Open: .....Comment from IBTA by William Futral (Intel): ..... 49

In my comments the notation 'Page xx' refers to all pages in the standard not roman numeral xx. All comments are editorial unless indicated with a '(T)' at the start of the comment.

**Figure 1 - SCSI document relationships**

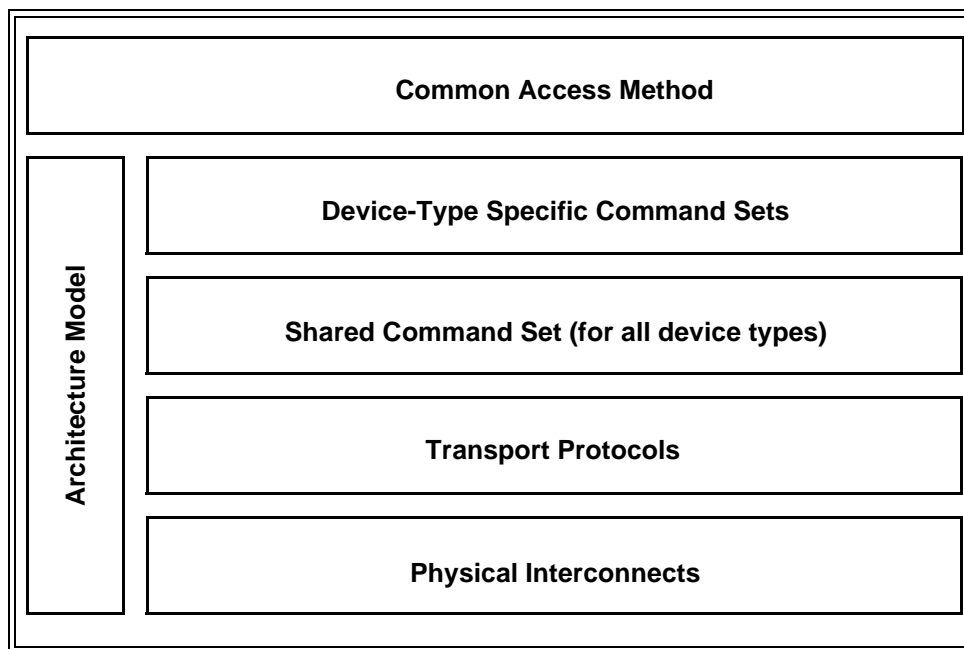
Delete CAM from figure 1 Delete these SCSI-2 standards from the example standards list:  
Serial Storage Architecture SCSI-2 Protocol SSA-S2P [ANSI X3.294:1996] Common  
Access Method: SCSI Common Access Method CAM [ISO/IEC 9316-421] [ANSI  
X3.232:1996]

"Figure 1 shows the relationship of this standard to the other standards?" But it doesn't. The SRP standard is not identified in the figure. Despite the disclaimer, layering of the blocks does suggest a hierarchy, protocol stack and system architecture. But the figure does not indicate the applicability of SRP to the implementation of a SCSI transport, as far as I can tell.

Figure 3 - Example RDMA channel establishment

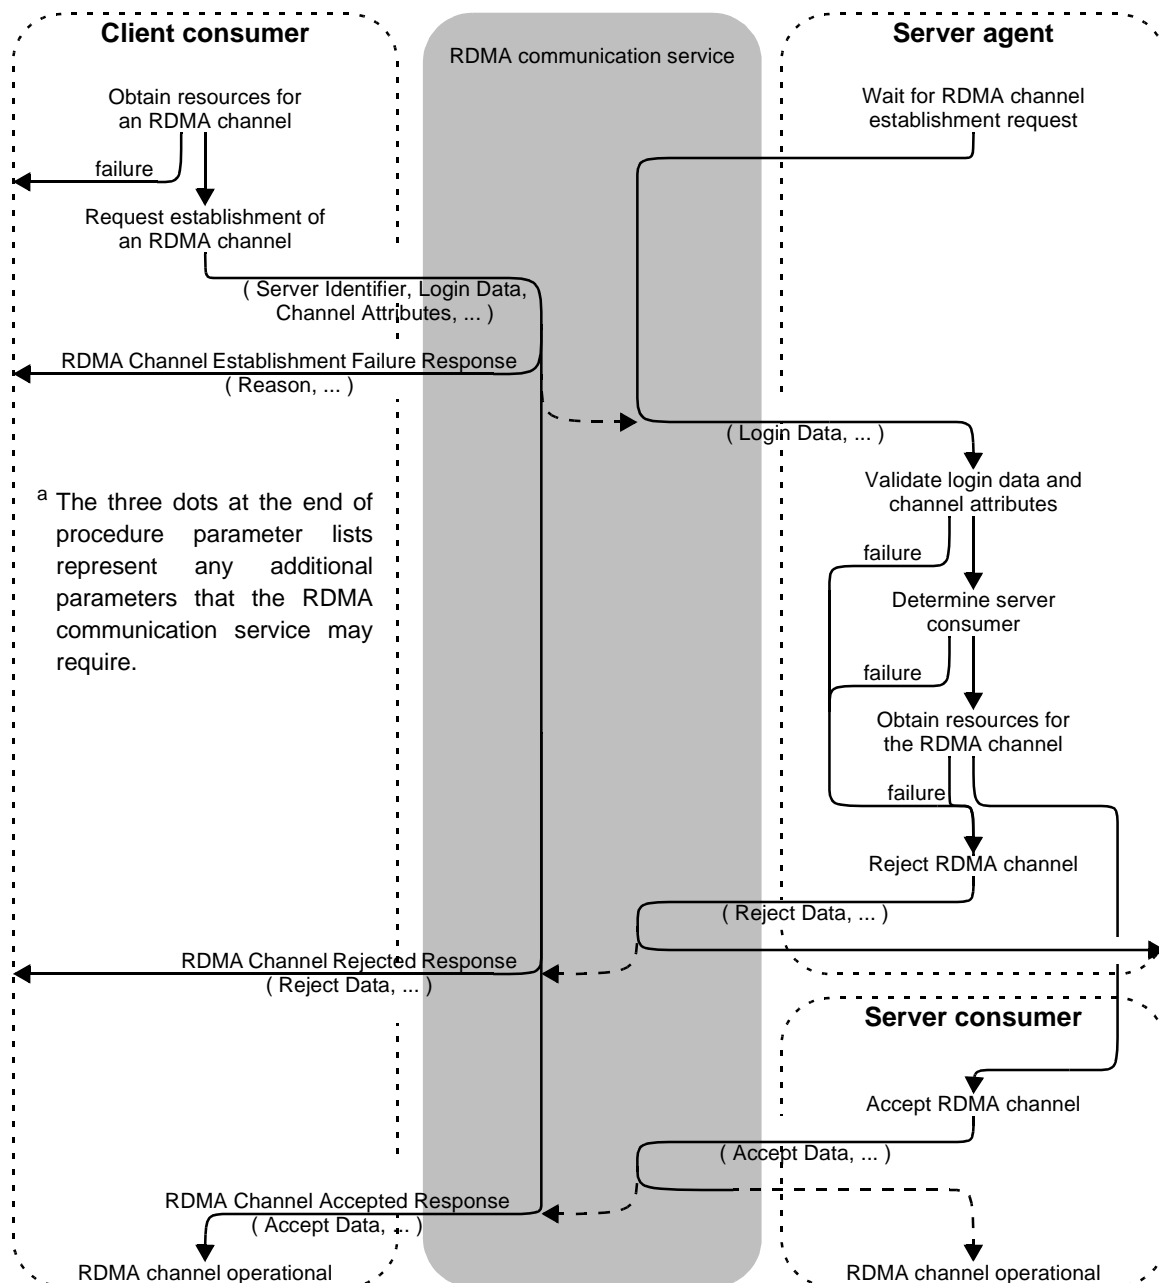
Page 9 - Figure 3 - line 40 - The arrow exiting to the right seems to be a dead end. Where does the flow go from there. All the other exit points are clear that one is not.

**Figure 4 - Memory descriptor mapping**

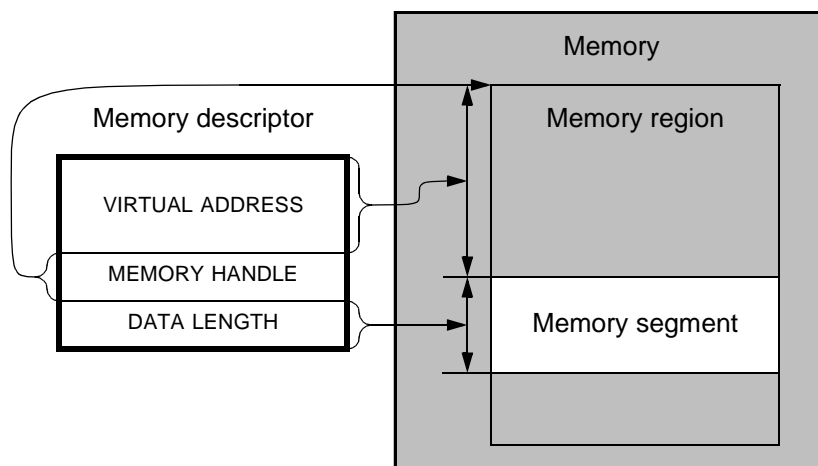
Page 17 - Figure 4 - The way the arrows are pointing for the virtual address implies that it is not the address of the first byte of the memory segment. It currently implies that it is the space from the memory handle to the beginning of the memory segment which is the memory region. It is also not clear as to what the boundaries are of the memory region. The current drawing implies it is only the area above the memory segment. I do not believe that is correct so it needs to be fixed.

**Figure A.2 - Model for a four step confirmed service**

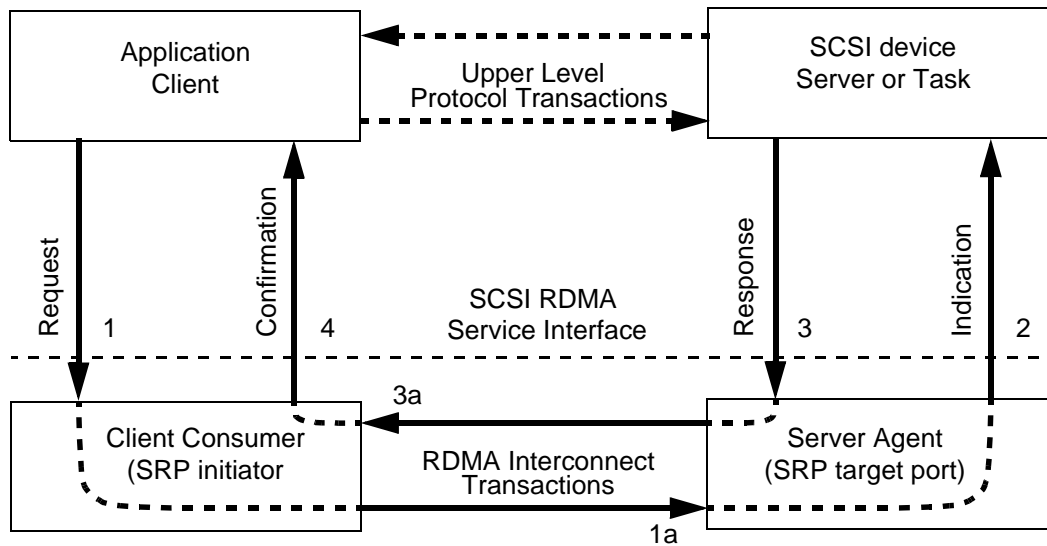
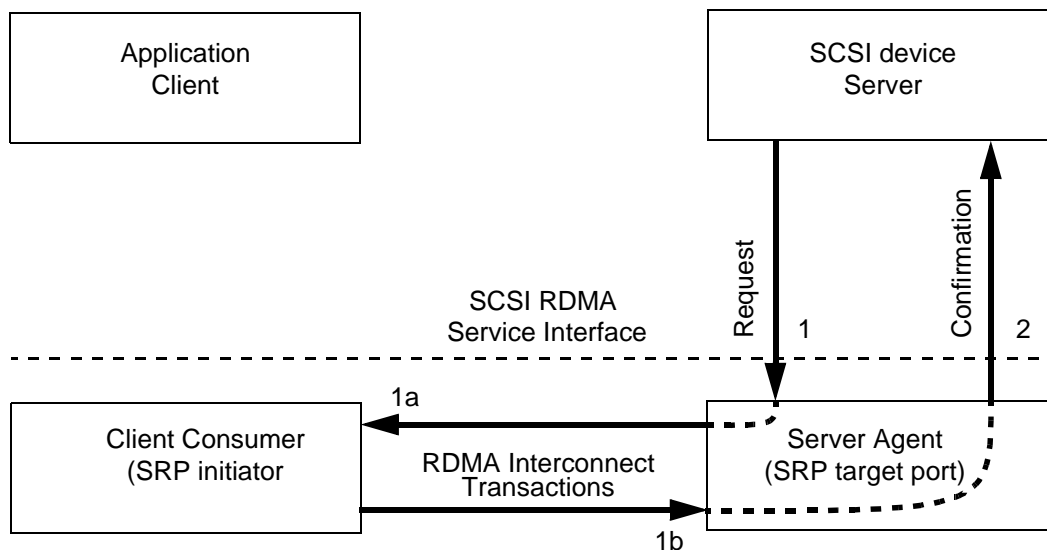
Page 46 - figure A.2 and A.3 - line 15 and 43 - The statement '(SRP initiator' should be '(SRP initiator port)'.

Figure B.2 - IB I/O unit example

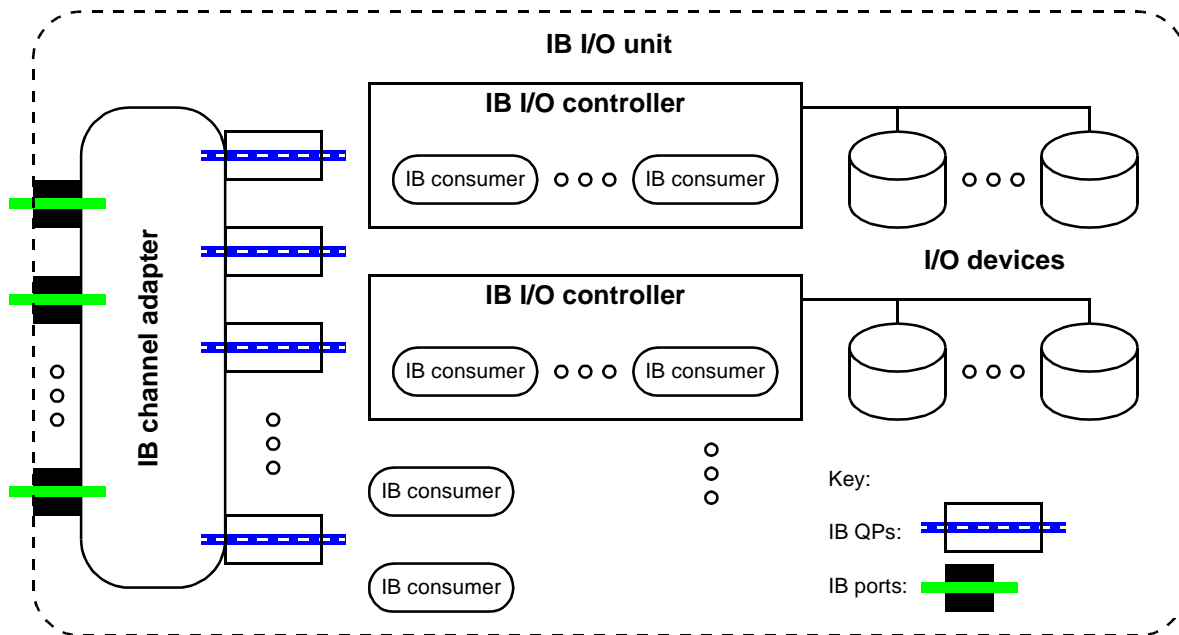
Figure B.2. Can I/O controllers be virtual objects?

Figure B.2. What is the purpose of allowing multiple IB consumers per IB I/O controller? Is it so that multiple IB connections can be terminated within an IB I/O controller? (This relates to the question above about correspondence between QPs and IB consumers.)

Figure B.2. How are shared LUs modeled? Do SRP target ports contain the "task router" function described recently by Penokie? Can two IB I/O controllers have an underlying LU in common, or is this functionality restricted to two IB consumers within the same IB I/O controller?

**Figure B.3 - SCSI architecture mapping**

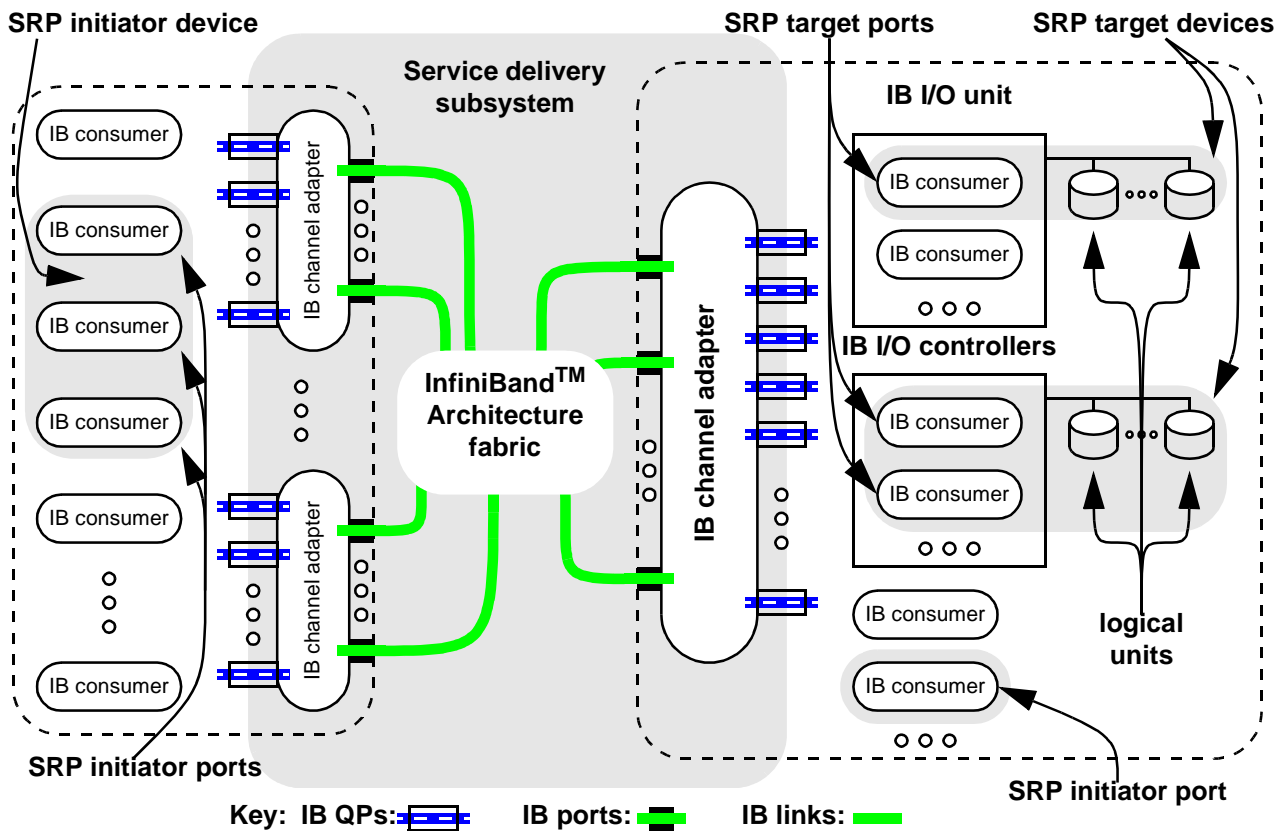
Figure B.3's equating of 'SRP Target Ports' with 'IB consumers' is problematic. A 'target port' is a sort of service access point--somewhere where interested parties initially go to obtain service, but without any implication that that's where the service is actually provided. (In IB, it's the Connection Manager that receives the initial connection request, interprets the ServiceID contained therein, and performs some magic that results in the instantiation of a QP bound to some entity that actually provides the target services). This target-services-providing entity fits the definition of 'IB consumer'. But the mapping of ServiceIDs-cum-SRP target ports onto such entities is clearly a matter of implementation, and could be one-to-many, many-to-one, or many-to-many Suggested Solution: One possibility: to the left of the IB Consumers show a table/list of service IDs within each IB I/O unit and label these entries as SRP Target Ports; use arrows to show a mapping from the entries to the IB Consumers, with e.g. one Consumer mapped to two IDs and another mapped to one ID to show that the mappings are not always 1 to 1. A further refinement might be to use another set of arrow between the Consumers and the QPs to show that the this mapping is also not 1 to 1

Figure B.3. What is the object indicated by the dashed lines in the initiator model, analogous to the IB I/O unit in the target model?

Figure B.3. and 56-1. Table B.2. The rules for constructing initiator ports seem entirely too lax. The text says, "Initiator port identifier should be constructed?" And then the Table indicates that GUID, for example, is the channel adapter GUID. Is there no meaning associated with the initiator port ID? Is the only design goal that the 16B port ID be globally unique? Will any GUID do at all? If so, let's be explicit about this, and let's not make any suggestions about the origin (and possible meaning) of the port name.

This comment is correct, but it's not immediately obvious how to incorporate it into a legible diagram. Note the further complication introduced by connection redirection. The IB consumer (IB QP and the software, etc. behind it) may be in an unrelated device / node / whatever, it need not be the same channel adapter or even an I/O unit. The sole purpose of the I/O unit and I/O controller is to obtain a service ID, connecting to that service ID may lead somewhere else altogether.
